HILL VALLEY - PHASE 2B

CITY PROJECT NO. 15860
CONTRACT NO. 9680

REVISION 1 - 04/29/26

REVISION 2 - 05/28/26

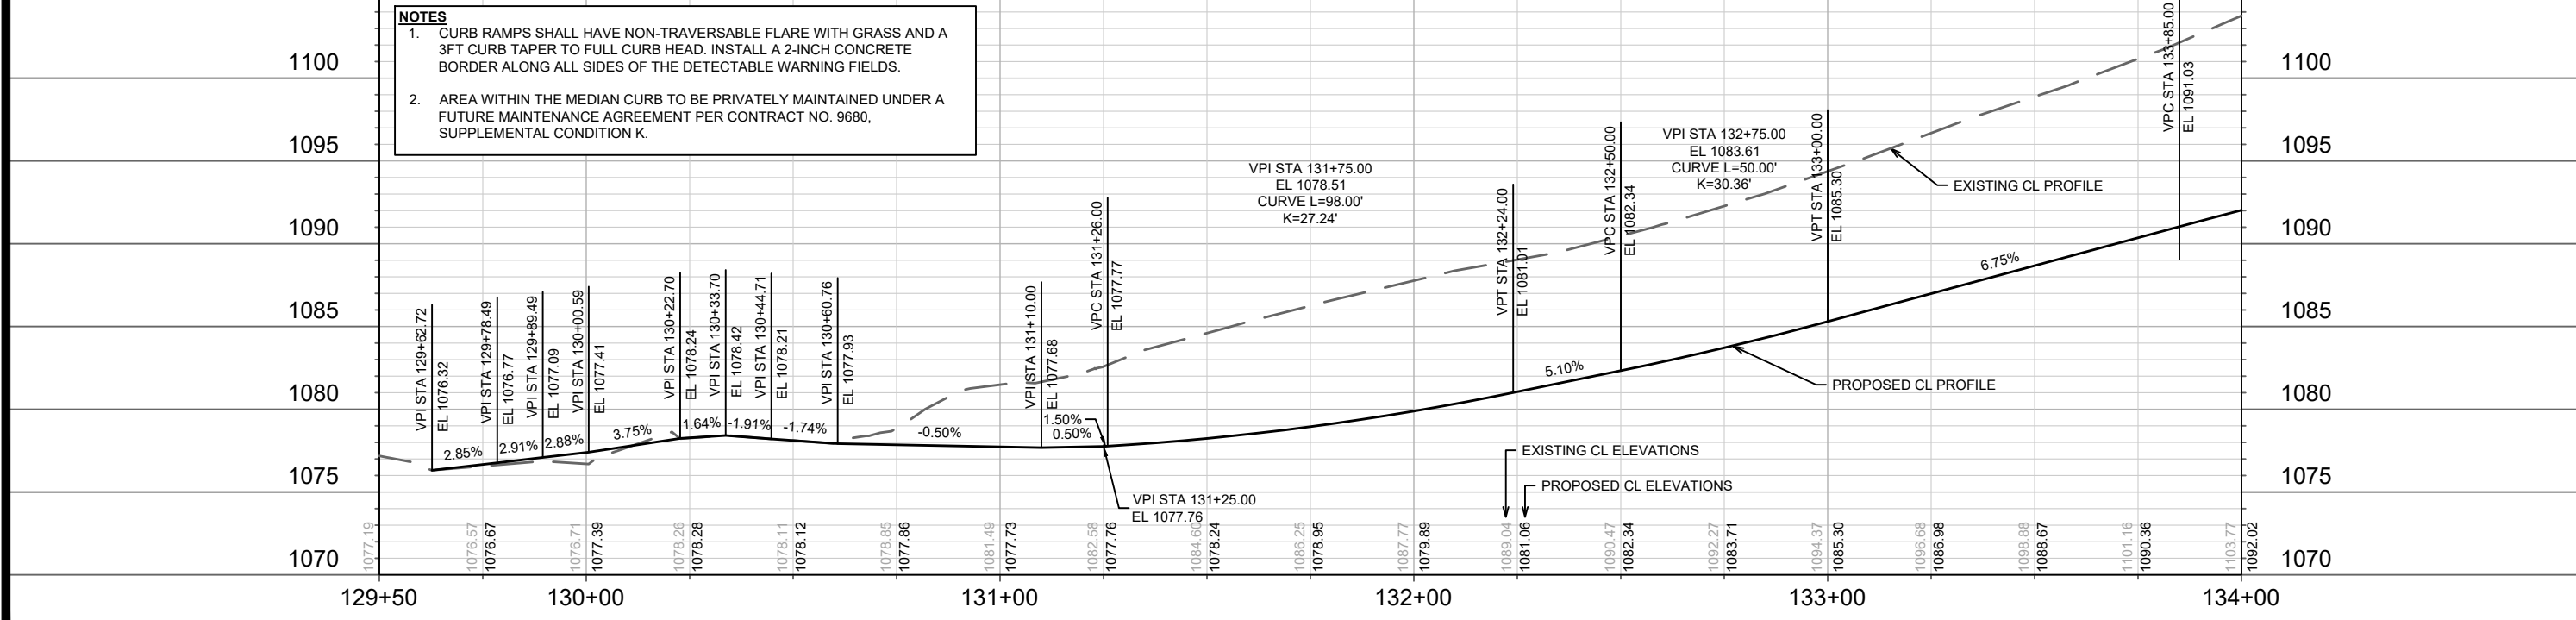
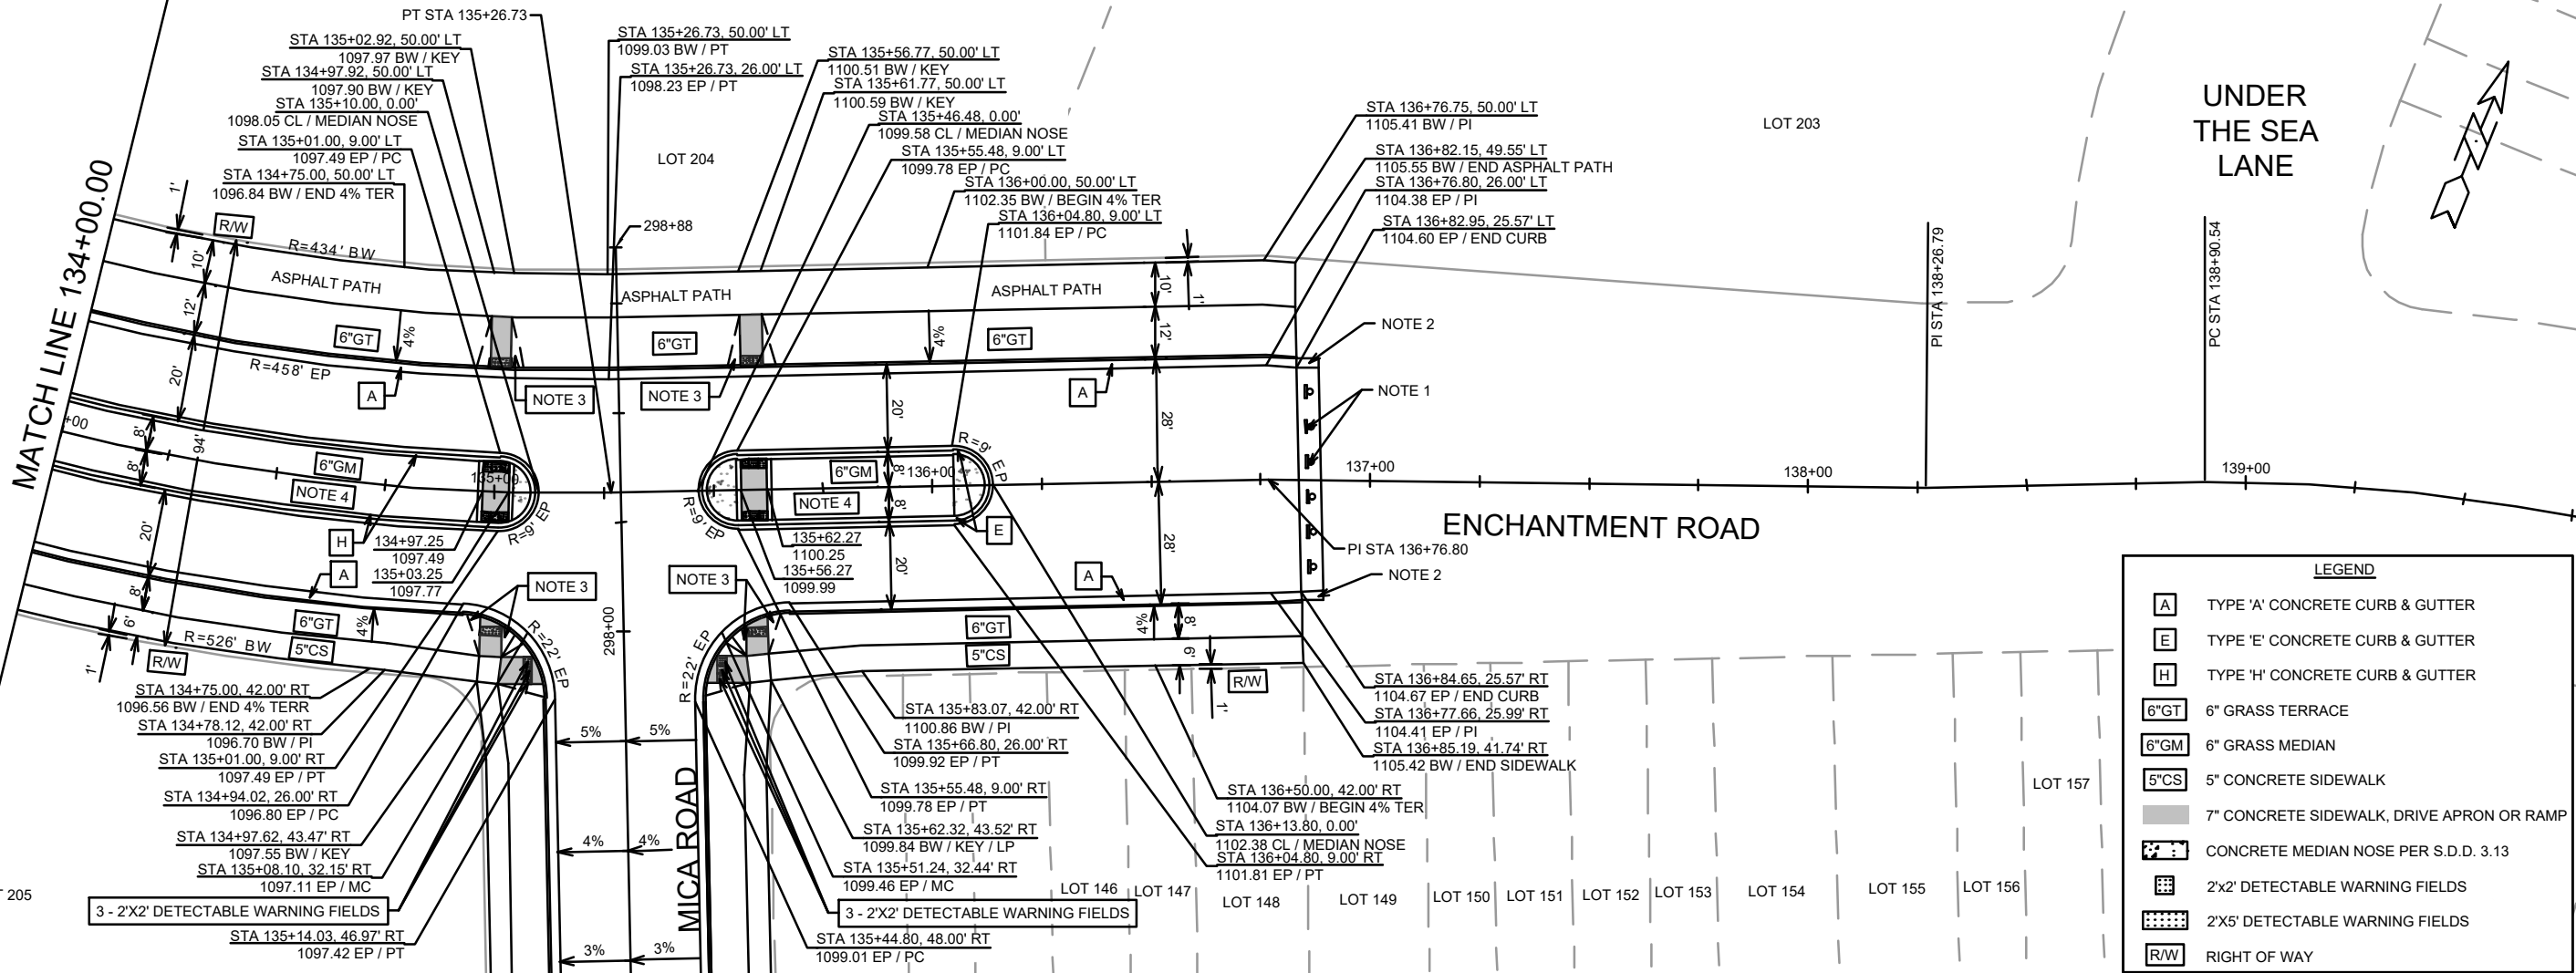
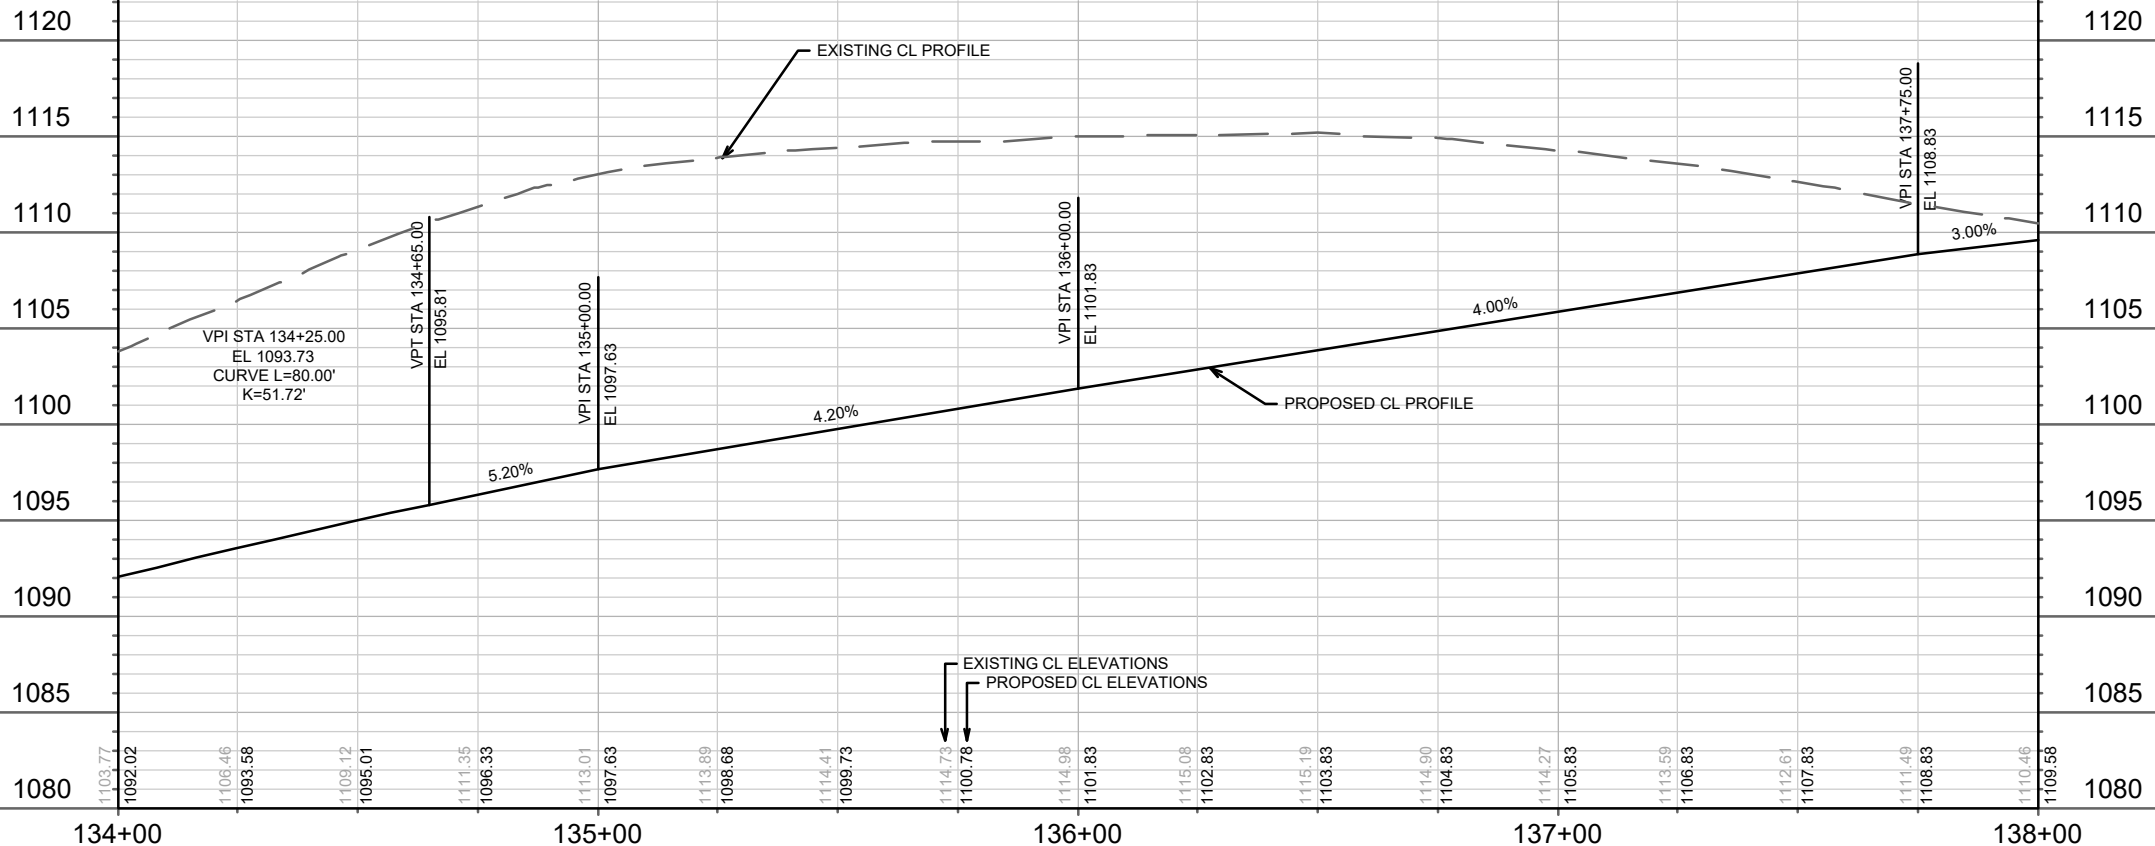
REVISION 2 - GCIT - 05/28/26
 - UPDATED PAVEMENT RESTORATION LIMITS
 - UPDATED LEGEND

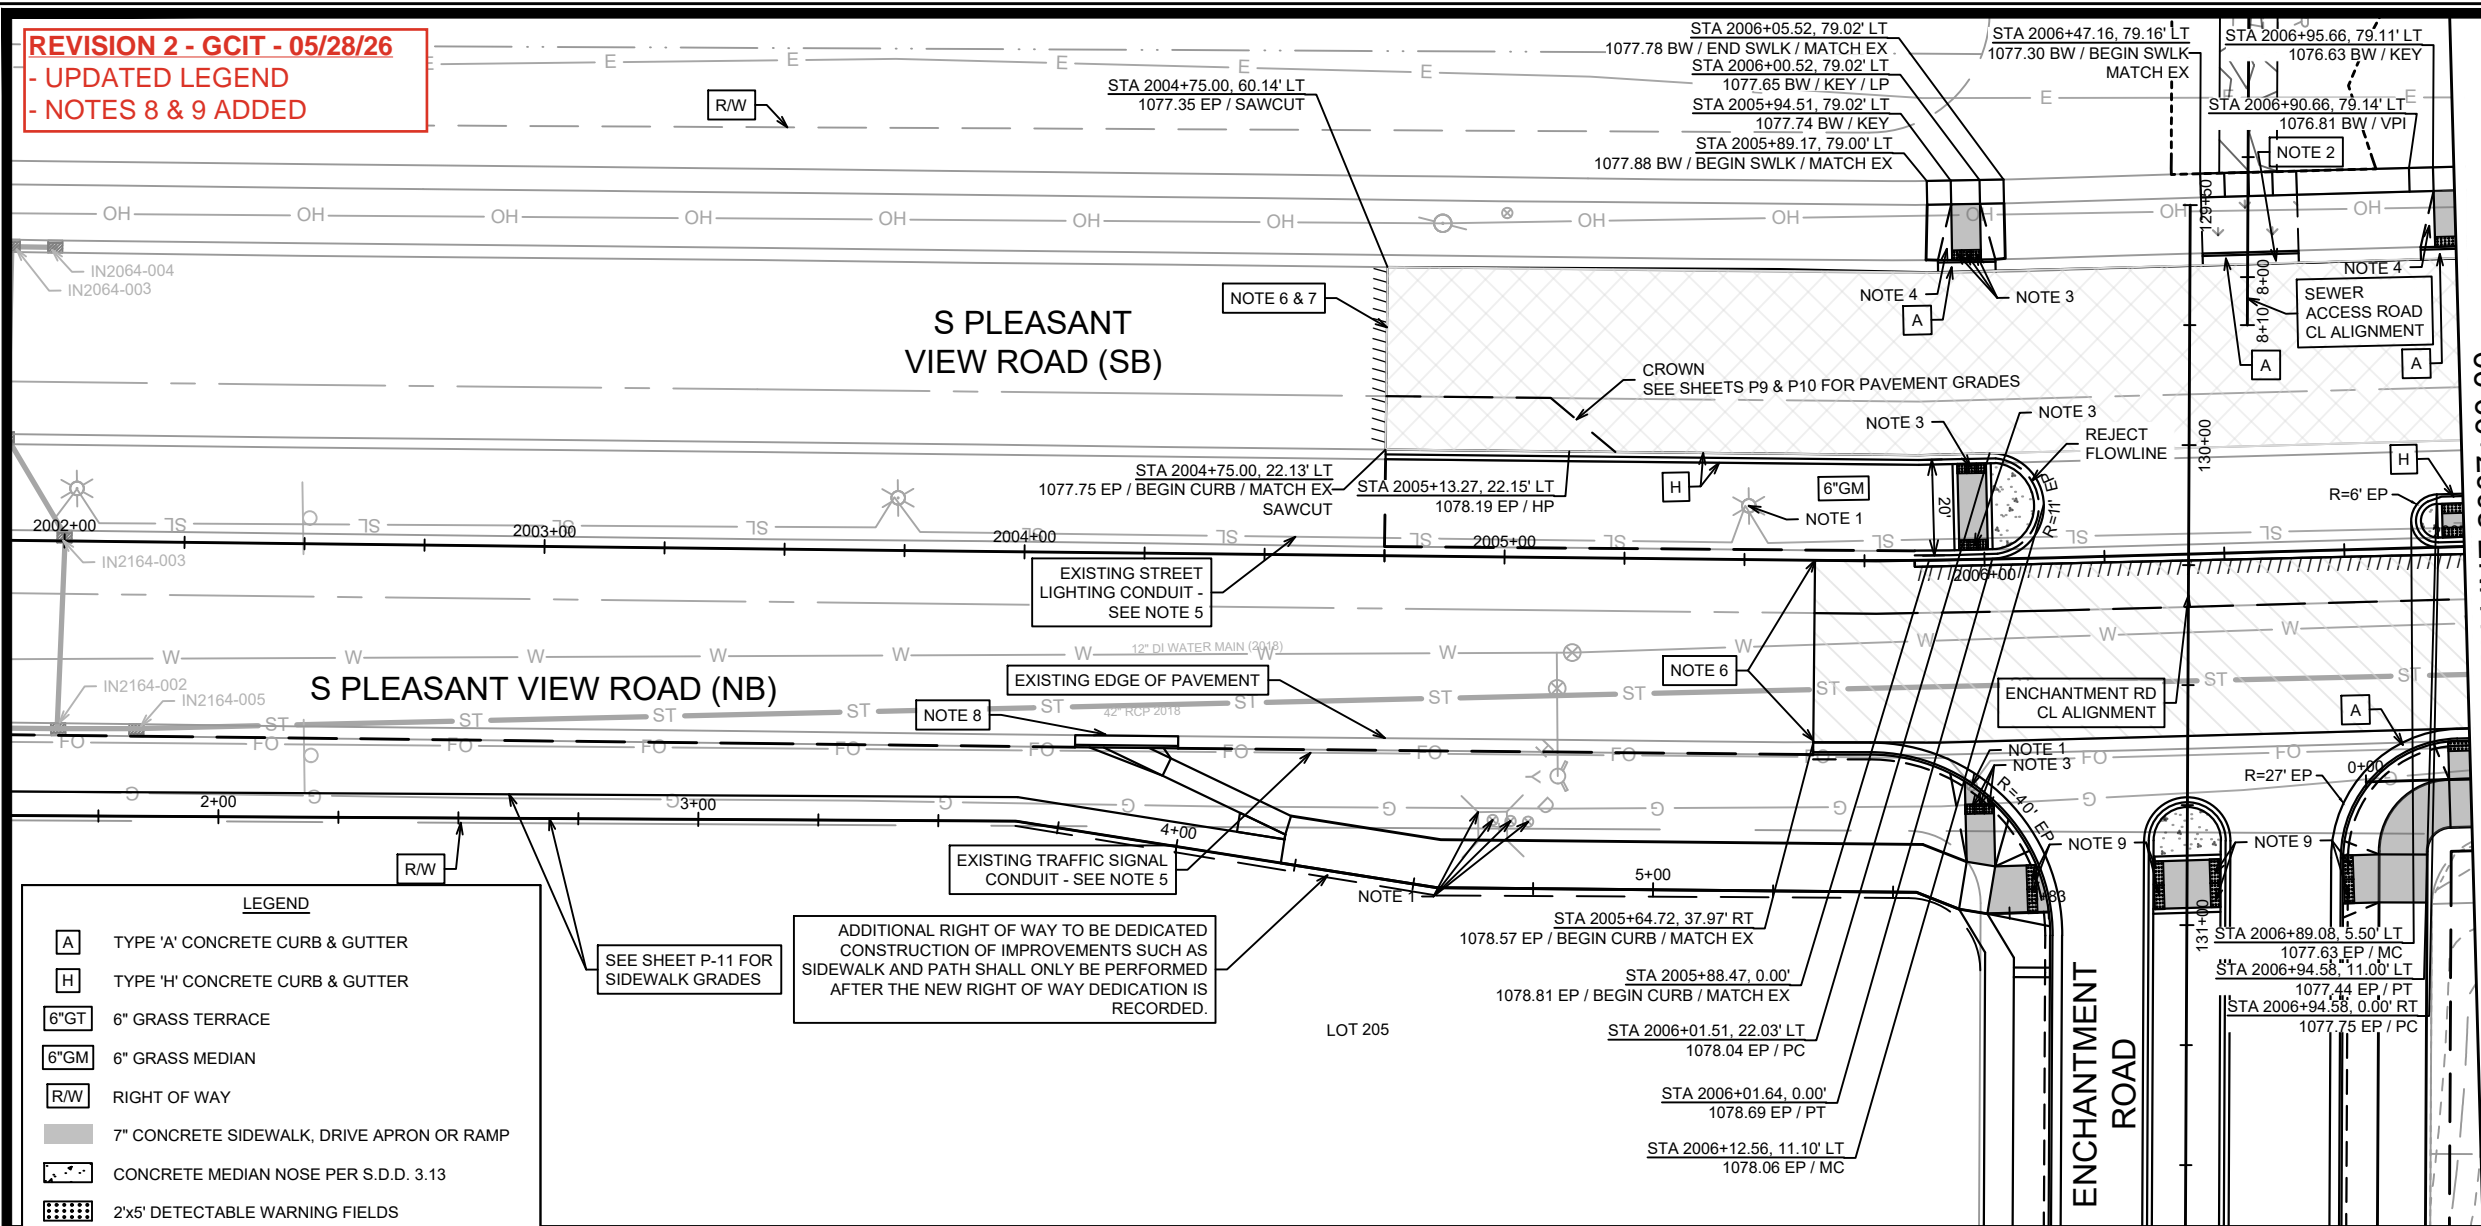
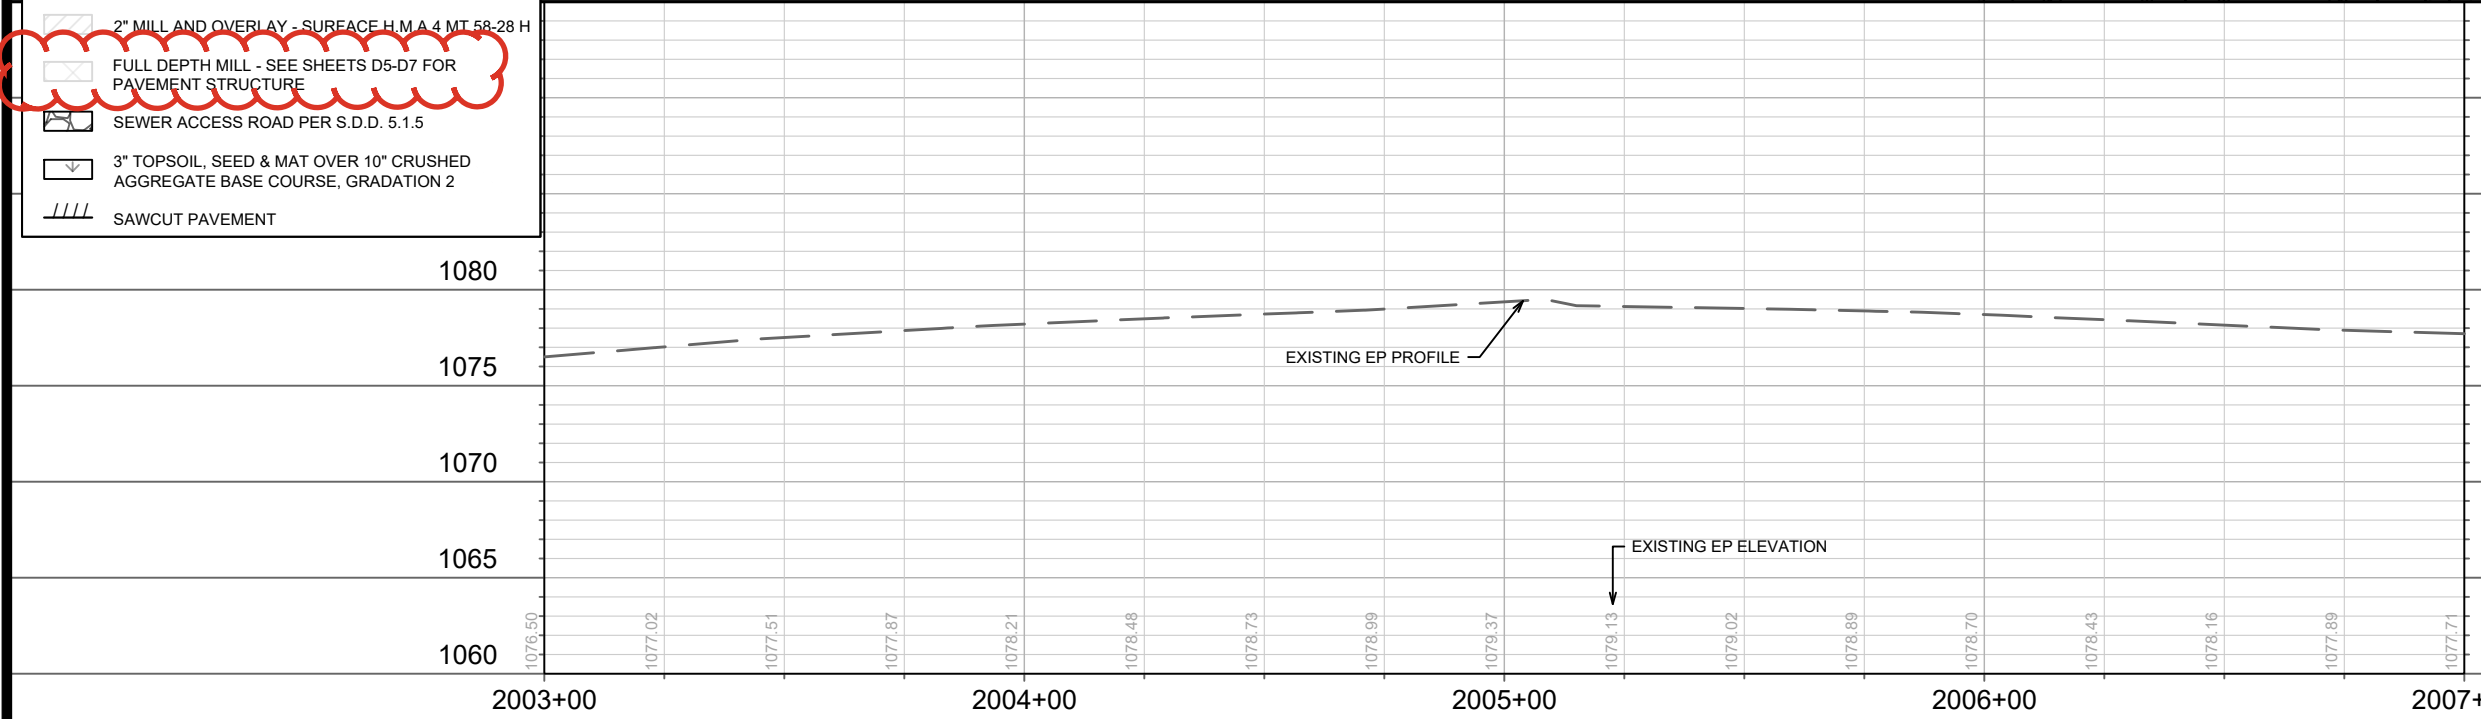
REVISION 2 - GCIT - 05/28/26
 - UPDATED LEGEND
 - NOTES 8 & 9 ADDED

8. IN LOCATIONS WHERE PAVEMENT RESTORATION IS NOT IDENTIFIED ADJACENT TO CURB REPLACEMENT LOCATIONS, IT IS ASSUMED THAT CURB AND GUTTER WILL BE REPLACED WITHOUT DAMAGING ADJACENT PAVEMENT. IF DAMAGED, PAVEMENT SHALL BE RESTORED AS NECESSARY TO MEET THE STANDARD PATCHING CRITERIA. LIMITS TO BE DETERMINED BY CITY CONSTRUCTION ENGINEER

9. 3 - 2'x5' DETECTABLE WARNING FIELDS
